Agenda
Village of Arlington Heights
Design Commission
Community Room, 3rd Floor

Arlington Heights Village Hall
33 S. Arlington Heights Road
Arlington Heights, IL 60005
June 13, 2017
6:30 PM

MINUTES OF
THE VILLAGE OF ARLINGTON HEIGHTS
DESIGN COMMISSION MEETING
HELD AT THE ARLINGTON HEIGHTS MUNICIPAL BUILDING
33 S. ARLINGTON HEIGHTS RD.
MAY 23, 2017

1 Renovated Front Elevation
A 3.1 1/16" = 1'-0"

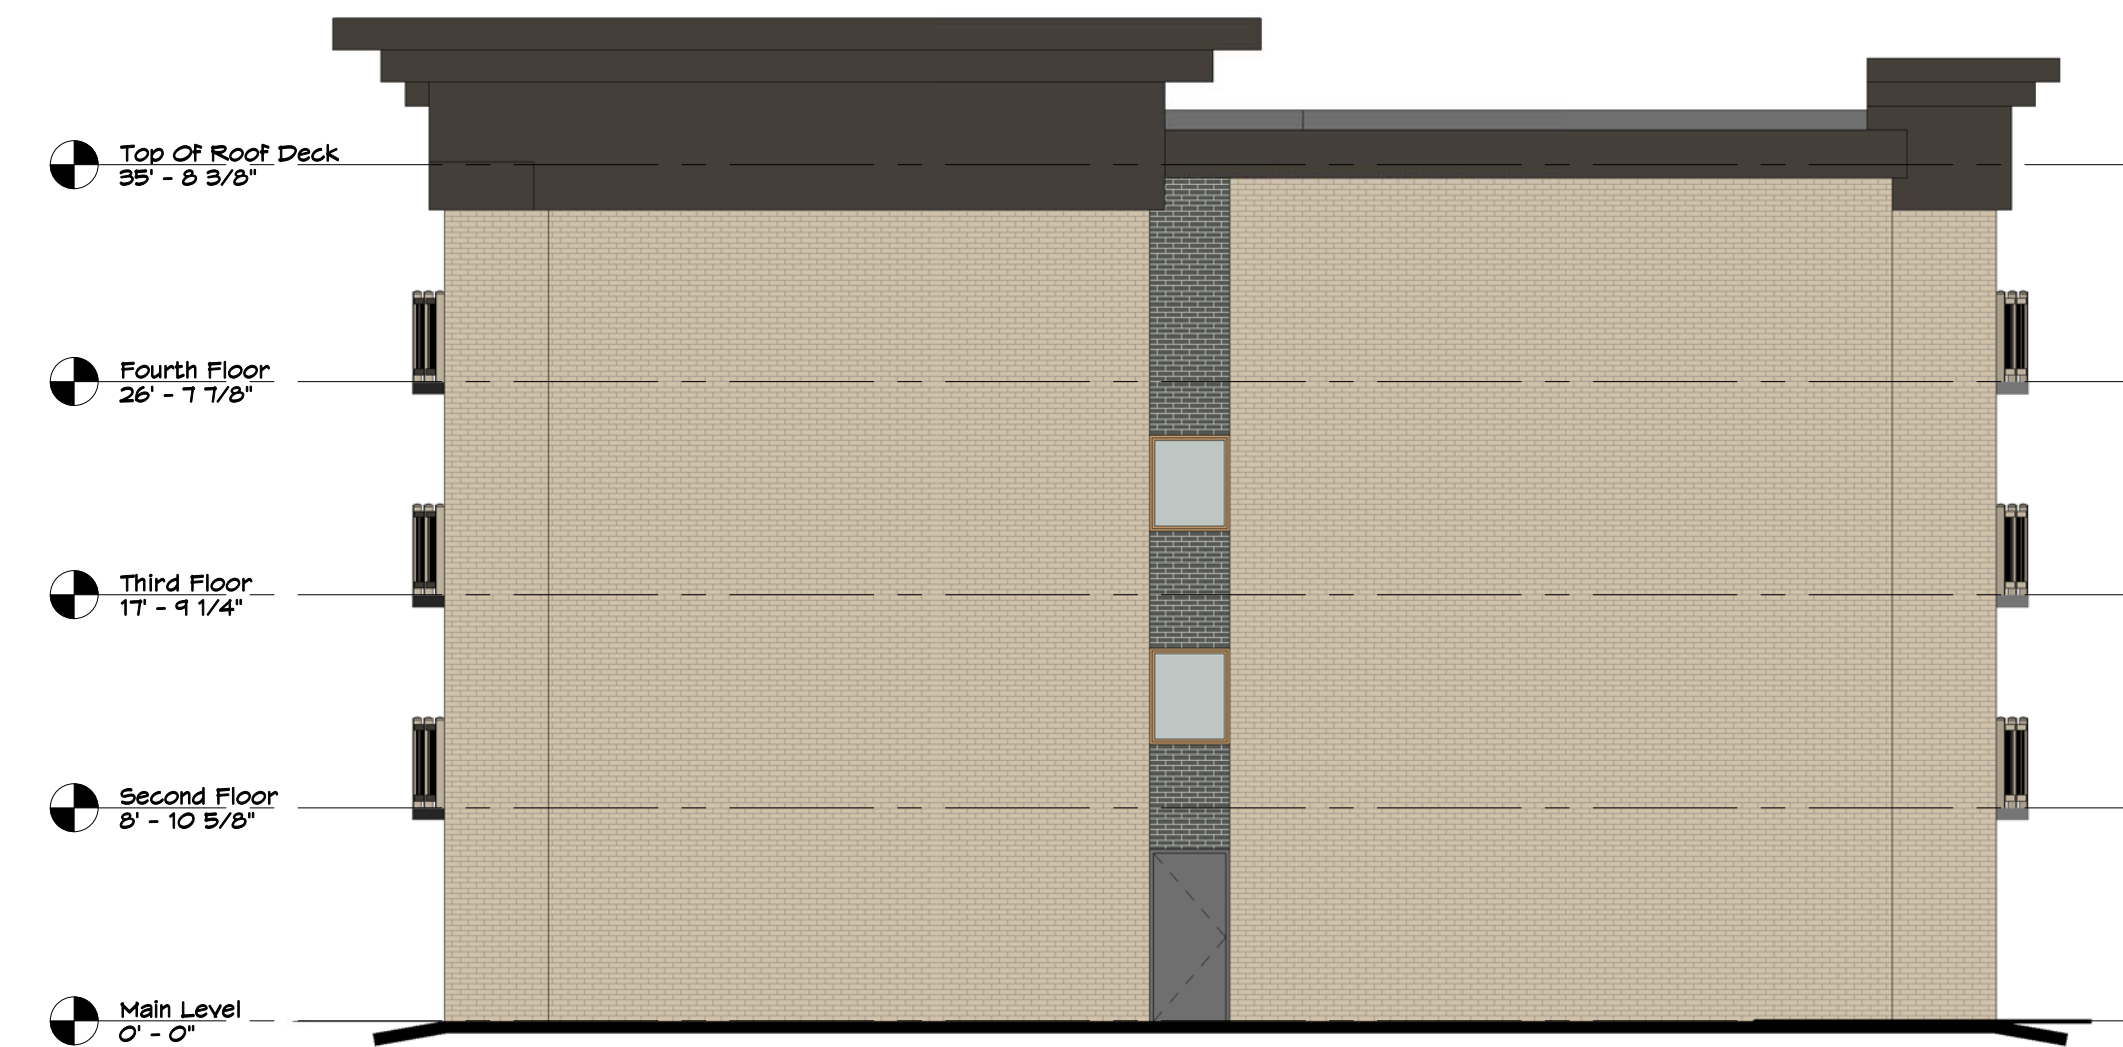
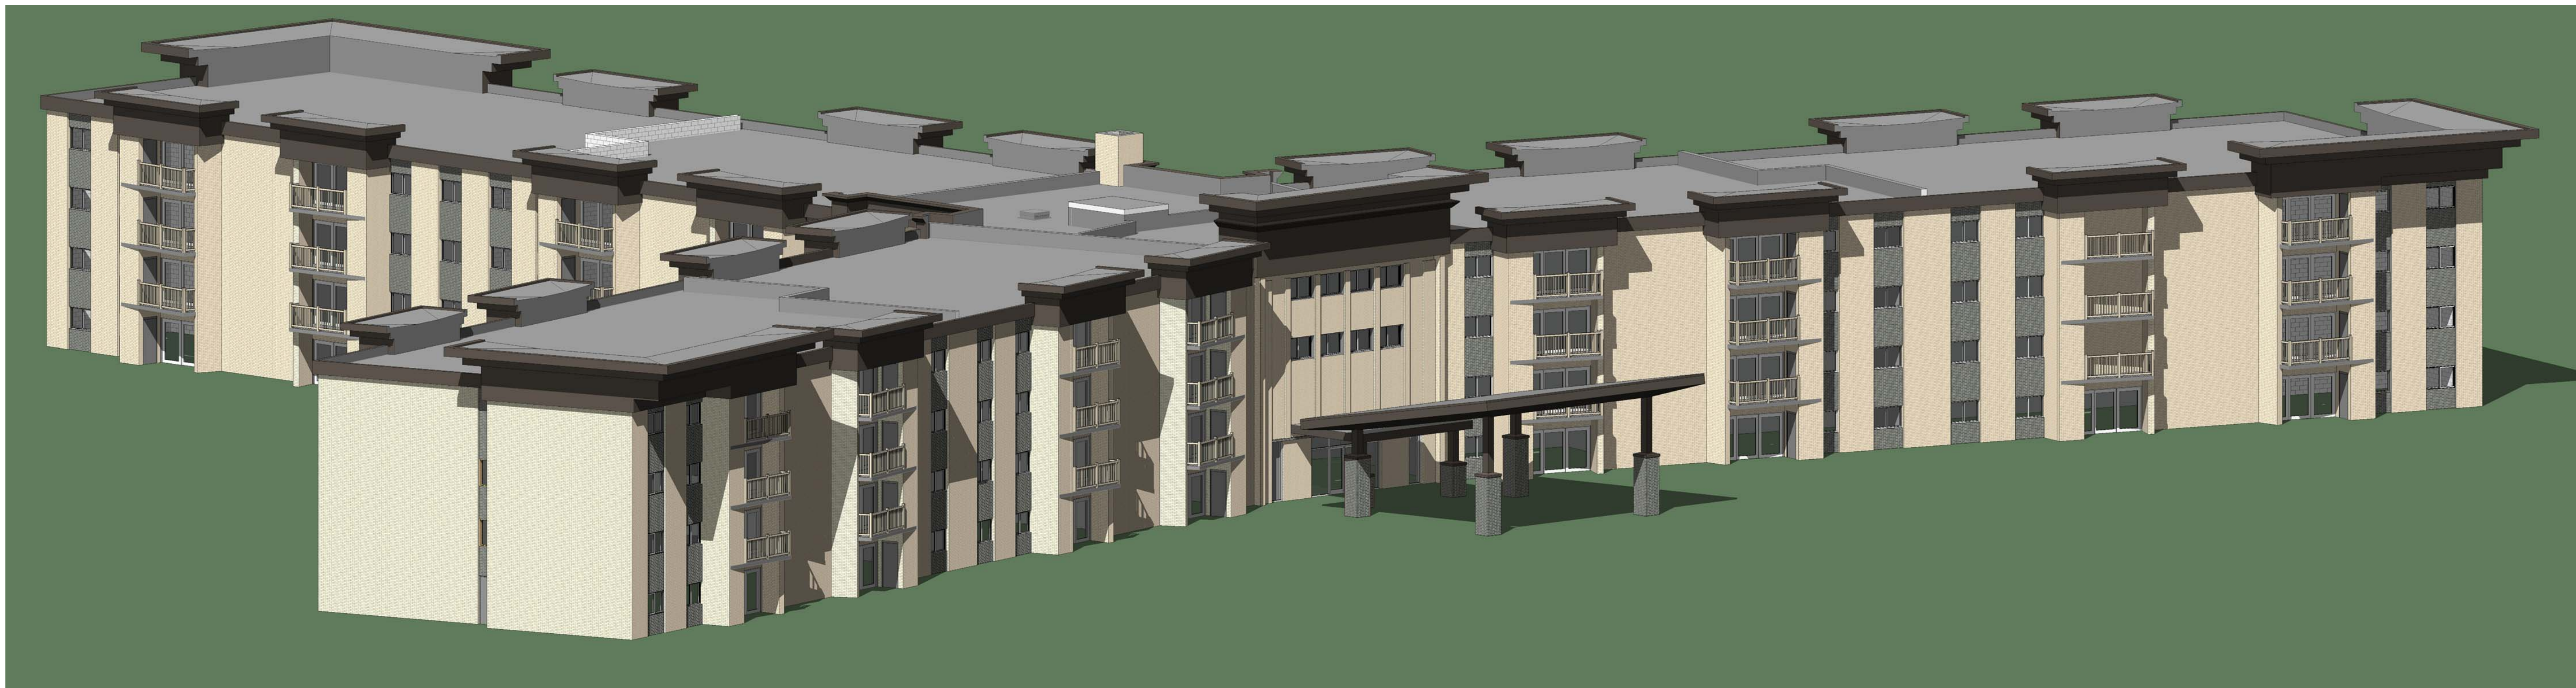
- a. Overall, the revised cornice design is a big improvement. It has much better scale and proportion.
 - b. It is recommended that the bottom of the “low” profile cornice be raised up about one foot to break the continuous horizontal line.

- a. Staff recommends a revised color scheme with off-white spandrel panels, a beige paint color for the walls (to complement the tan railings), and a dark brown cornice.

1. Raise the bottom of the “low profile” cornice detail about one foot.
2. Study a new paint scheme with dark brown cornice, beige walls, and off-white spandrel panels, field mockup to be approved by Staff.

RECOMMENDED
REVISION

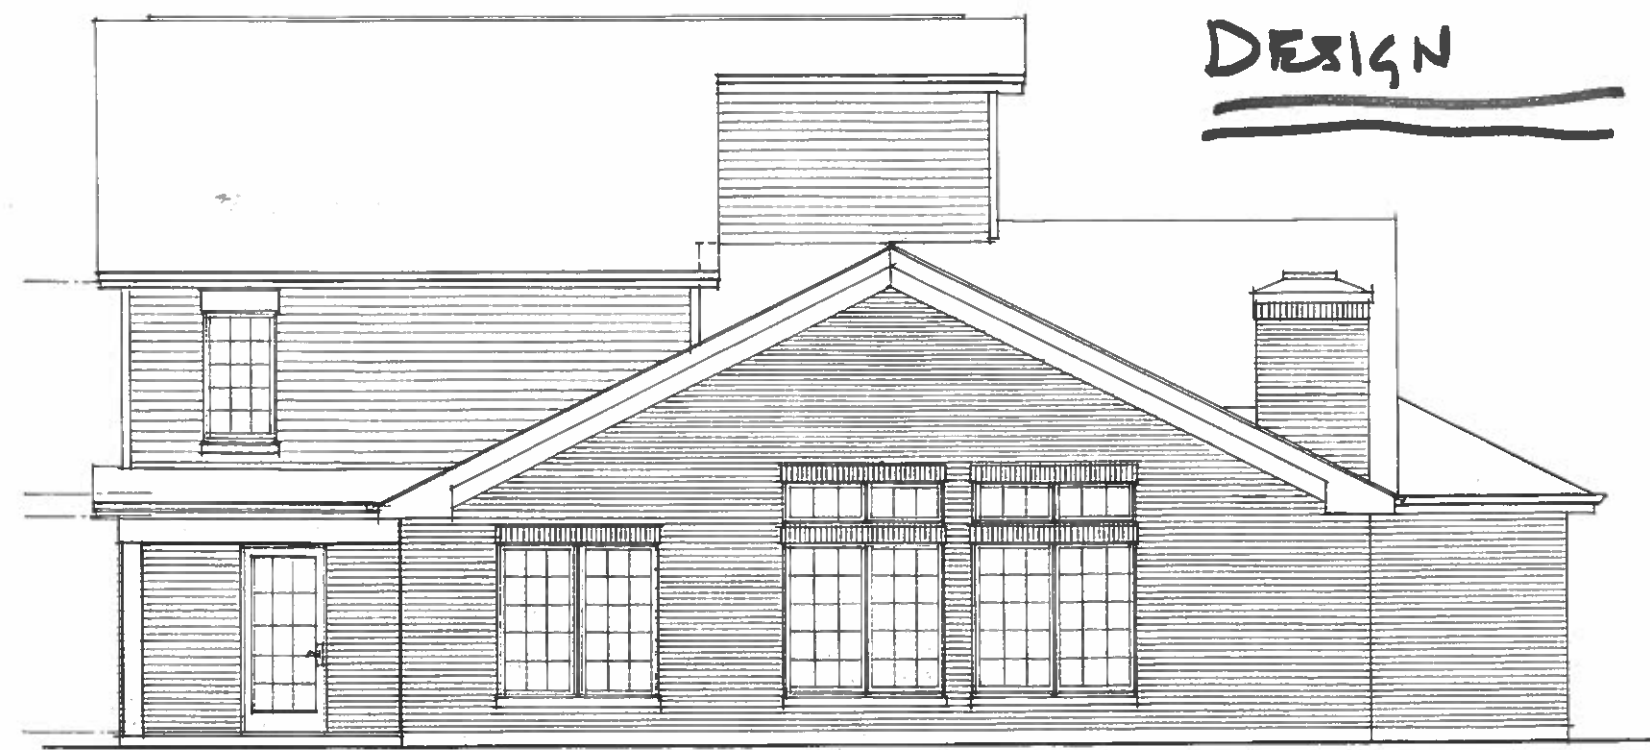
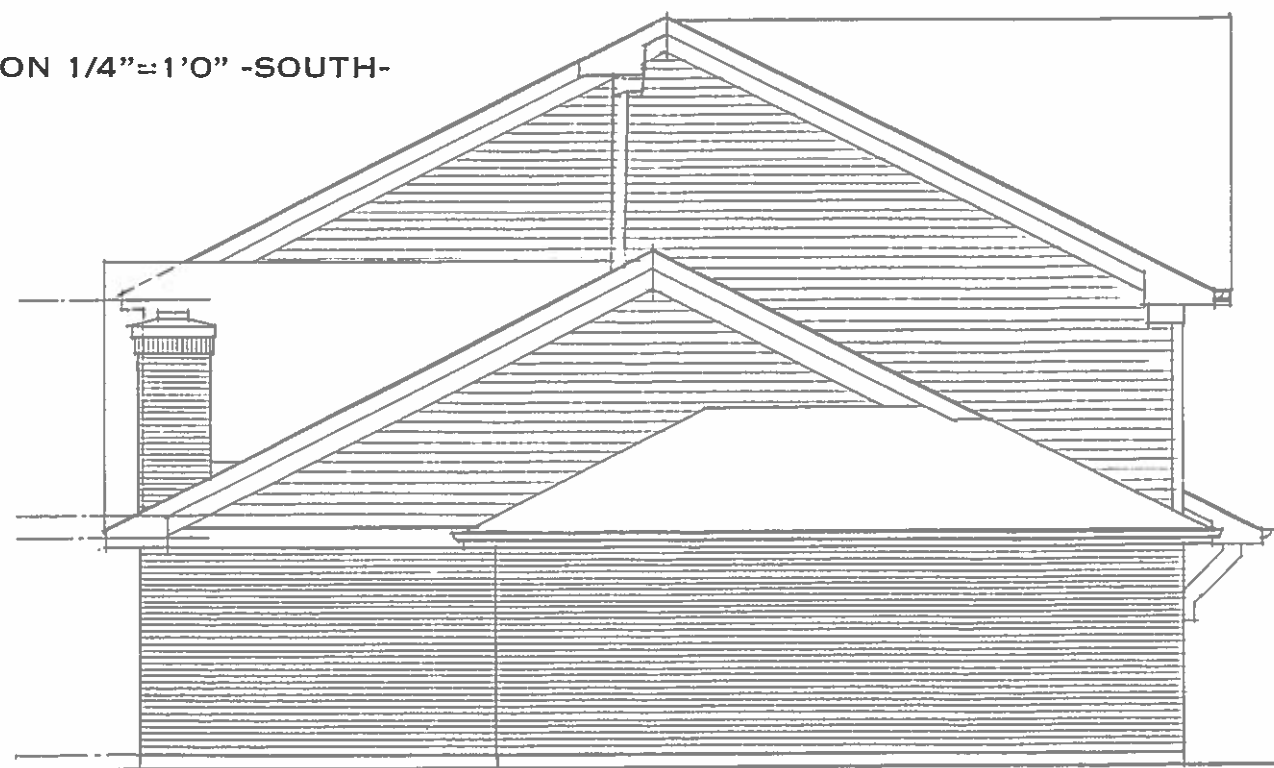
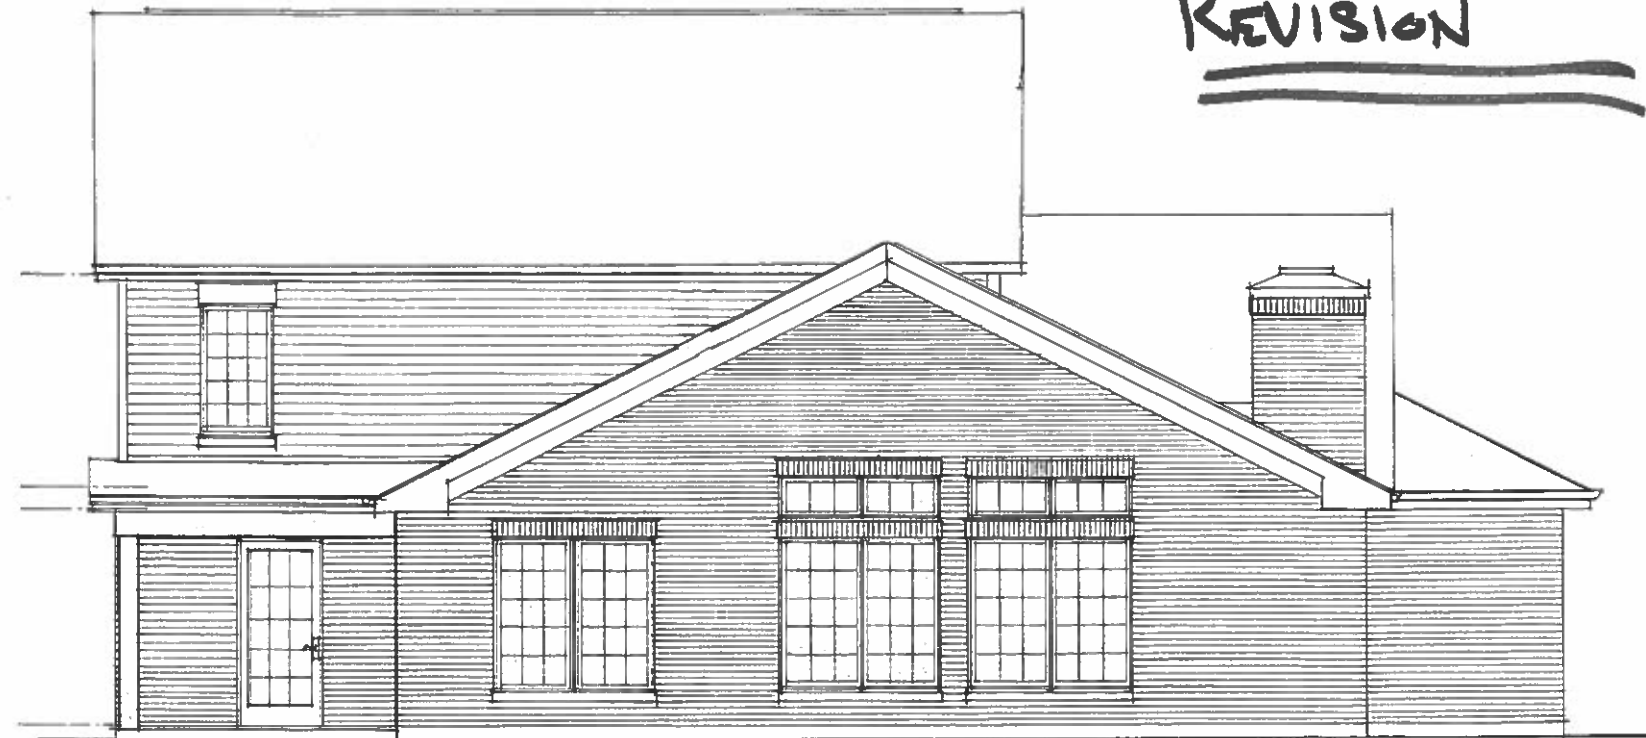
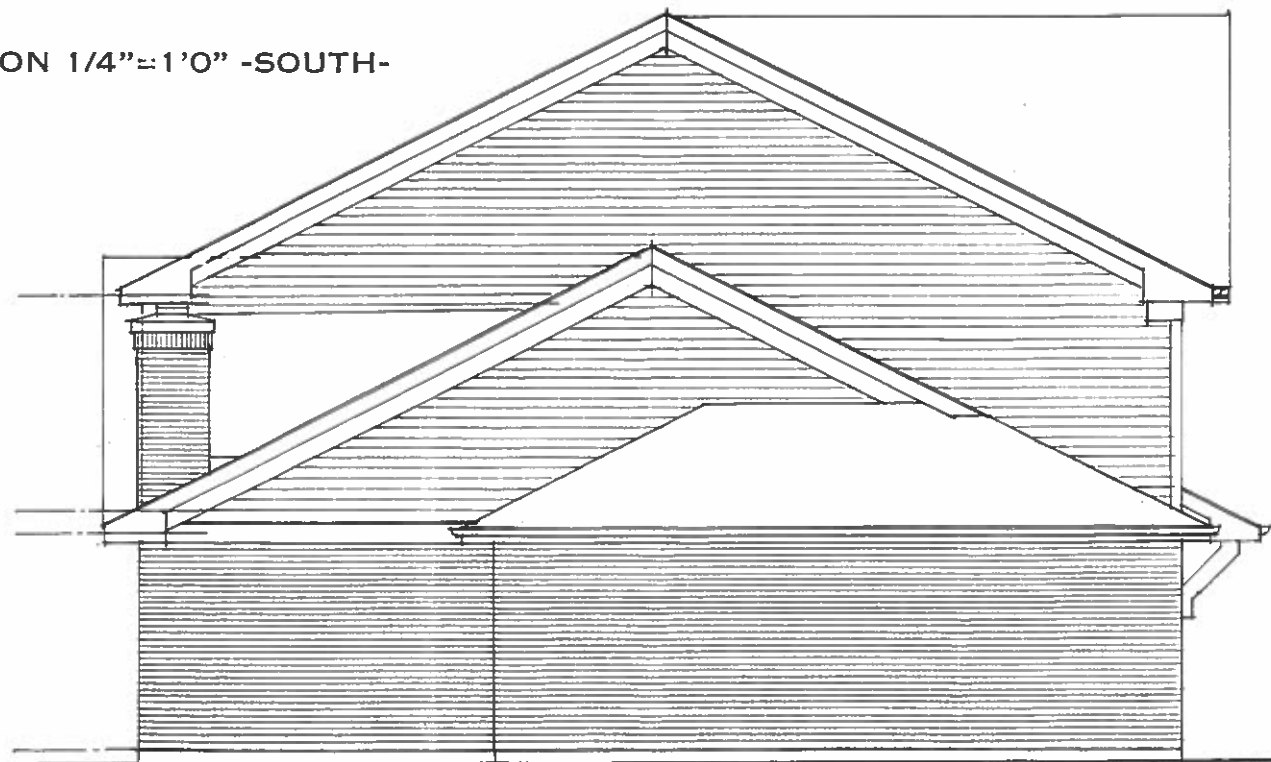
It is recommended that the Design Commission **approve** the proposed addition to the existing single-family residence located at 245 W. Maude Avenue. This recommendation is based upon the architectural plans received on 6/2/17, and the following:
